Our File: 9506

January 14, 2014

**Re: Response to Burnside Review of Summary of Drilling and Testing of New Well M15 at Hidden Quarry Site
Burnside File No.: 300032475.0000**

**Re: Summary of Drilling and Testing of New Well M15 at Hidden Quarry Site
File No.: 300032475.0000**

Figure 5: M2 Response During M15 Testing

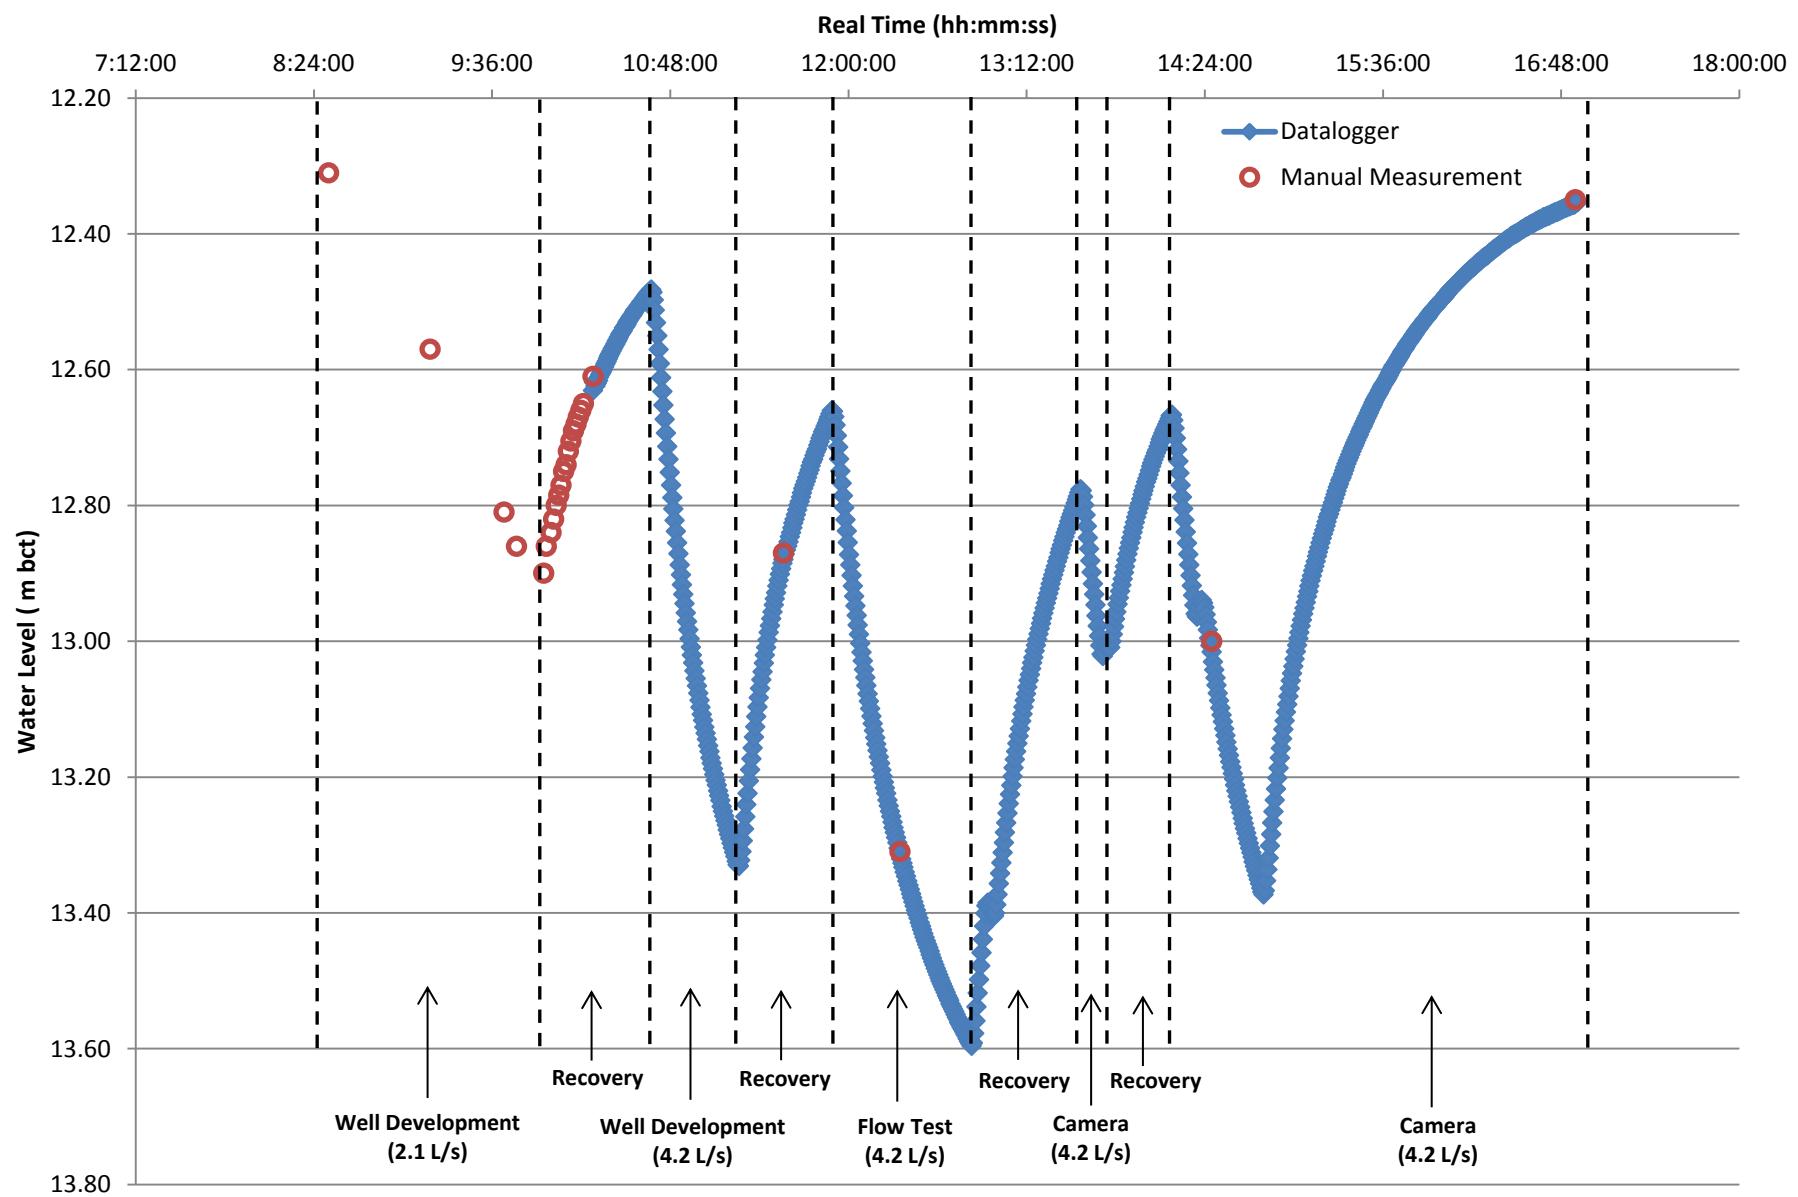
Notation should be added to Figure 5 (Well M2 response) to indicate which portions of the graph represent the pumping test, flow profiling and pumping video.

We have added notation to Figure 5 (attached) indicating which portions of the drawdown correlate to pumping, flow profiling and video logging.

Figure 2:
Downgradient Private Wells

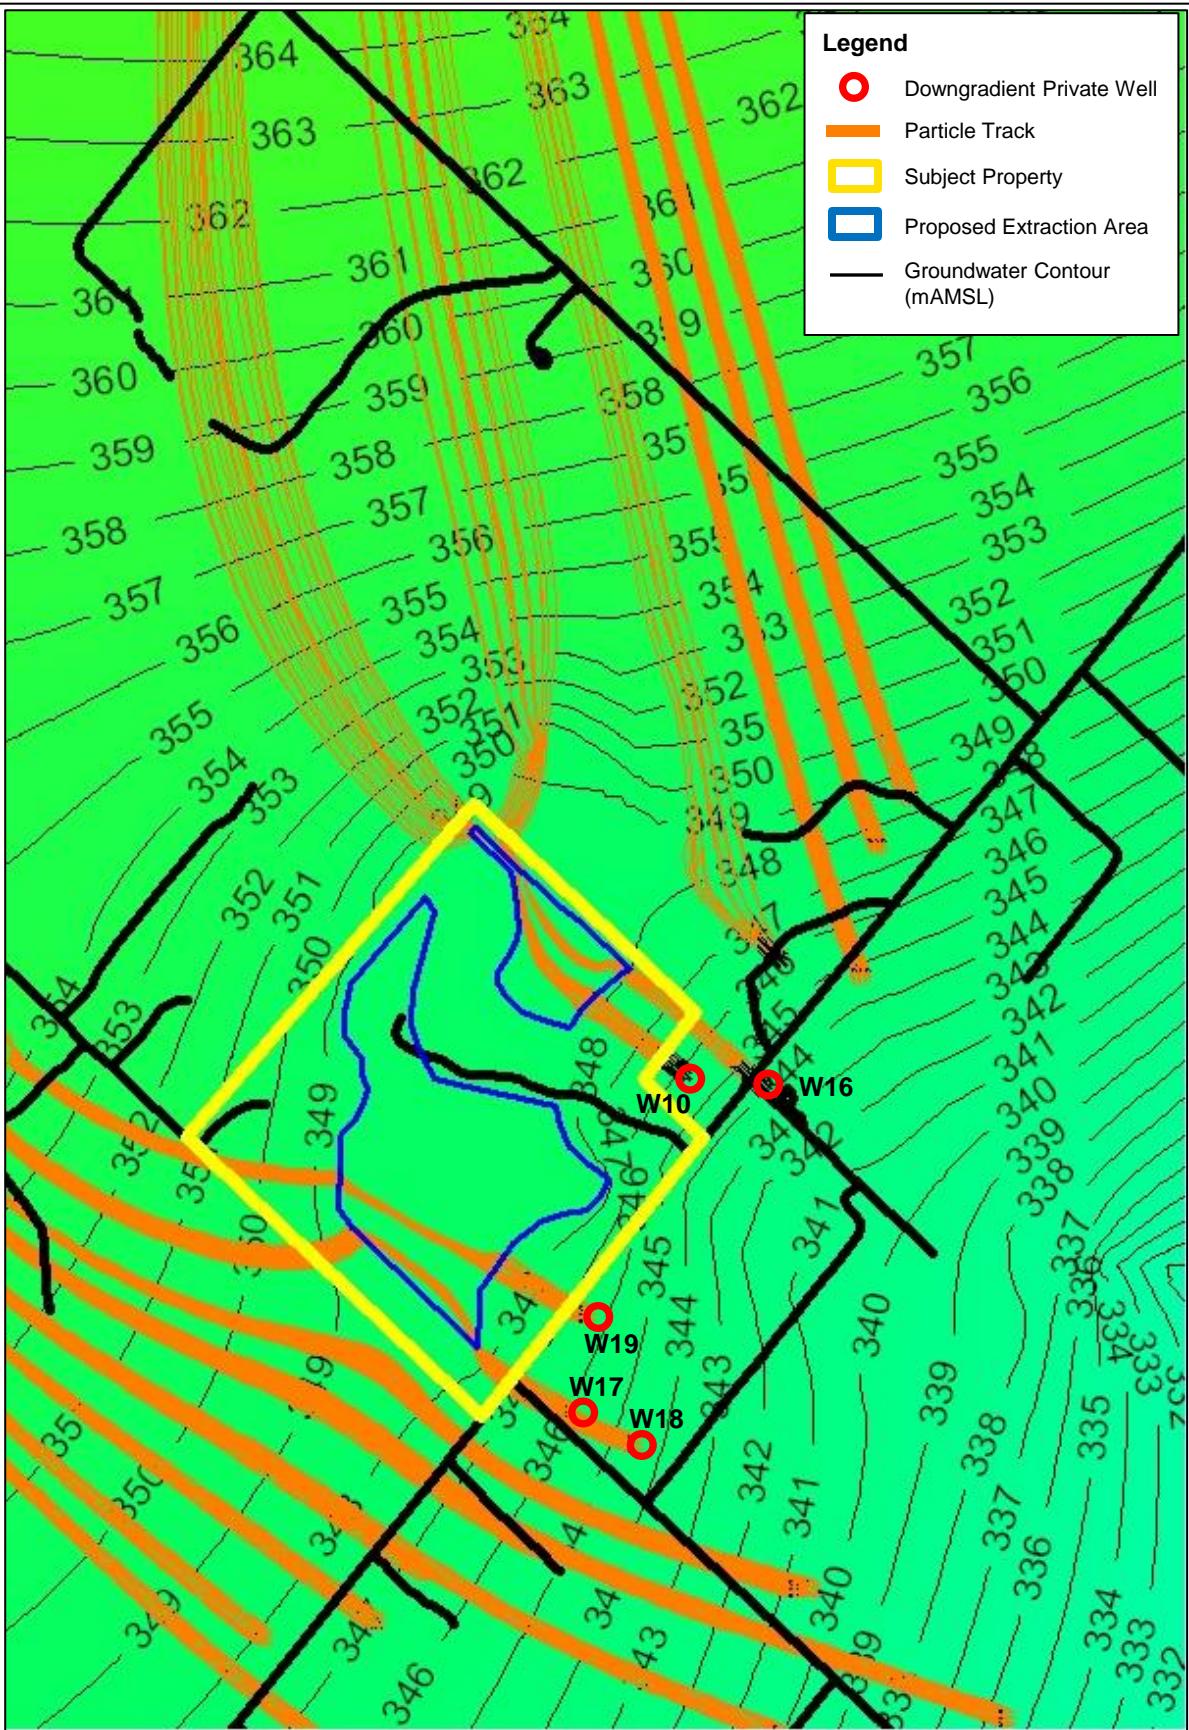
Once the quarry pond is created, there will be water mixing from all directions and depths. Harden should provide additional detail on how the exposure of the groundwater to air will impact iron (the concentrations at M2 are already above the Ontario Drinking Water Quality Standards (ODWQS)). Although iron is an aesthetic parameter, Harden should comment on the potential for iron to increase in downgradient wells; possibly causing problems with fixture staining and odours. Similarly, a mass balance calculation should be performed to estimate the nitrate concentration at the downgradient end of the quarry. Once the pond is created during extraction, it is anticipated that surface water pathogens such as Cryptosporidium and Giardia possibly will be present. These have the potential to move rapidly through bedrock fractures, impacting nearby domestic wells.

Two ponds will remain upon maturity of this site. These ponds are upgradient from five private wells as shown on Figure 2 as determined by reverse particle tracking from the private wells. At least one of the private wells (W19) is already utilizing an Ultra Violet Light to treat for a chronic bacteriological issue in the well water.
